ST012 Remedial Action

Field Variance Memorandum #4 – Additional Site Characterization

Subject: **Proposed Drilling Work Plan for Additional Site Characterization
Former Liquid Fuels Storage Area (ST012)
Former Williams Air Force Base – Mesa, Arizona**

Site ST012 EPA/ADEQ Concerns for LNAPL and Groundwater (Benzene) Characterization

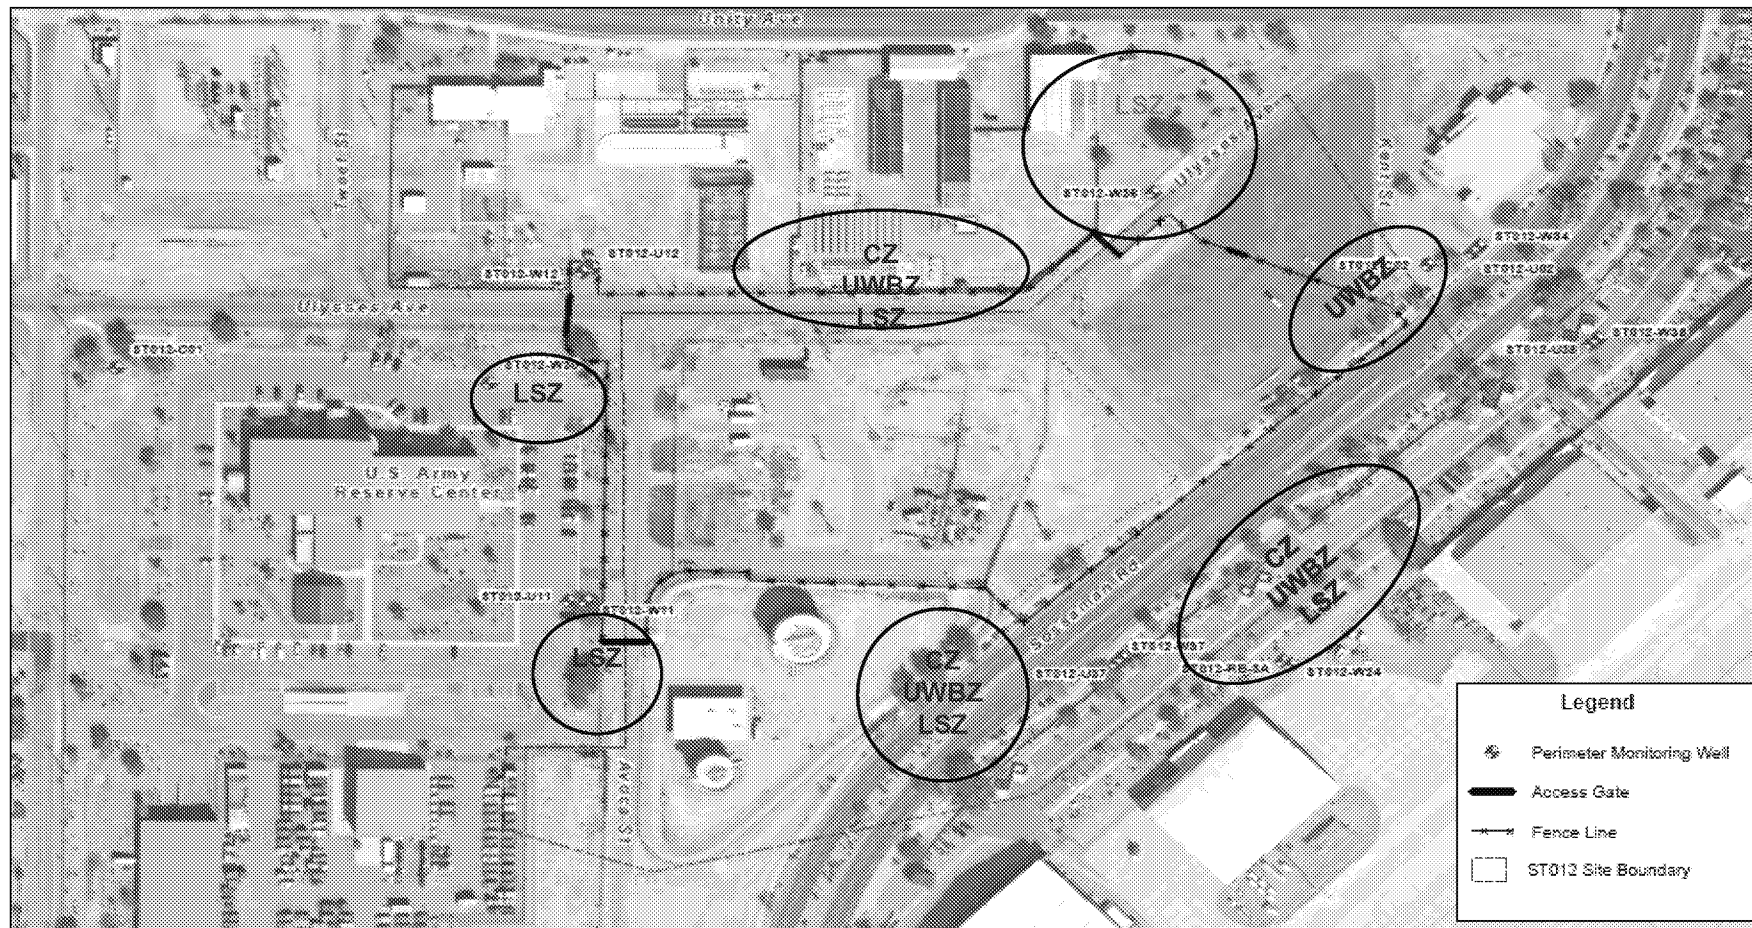
Red – LNAPL and dissolved phase

Green – dissolved phase

Blue – LNAPL

○ Area of EPA/ADEQ comment

Site ST012 EPA/ADEQ Concerns for LNAPL and Groundwater (Benzene) Characterization

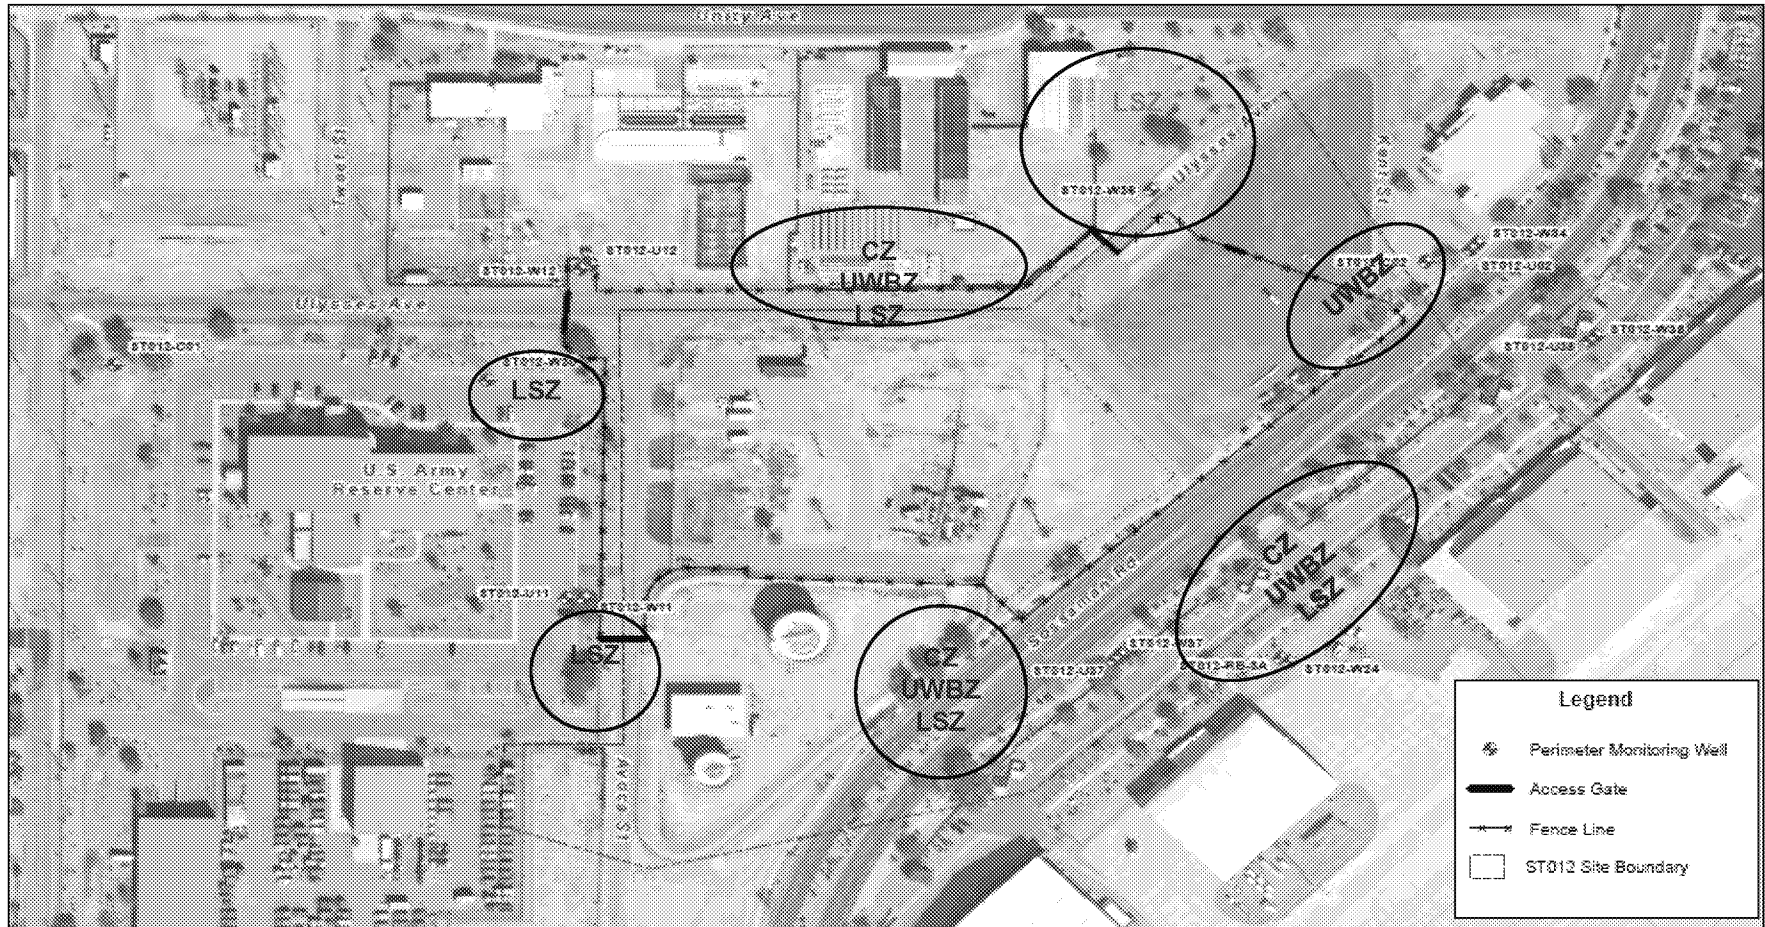
Red – LNAPL and dissolved phase

Green – dissolved phase

Blue – LNAPL

Area of EPA/ADEQ comment
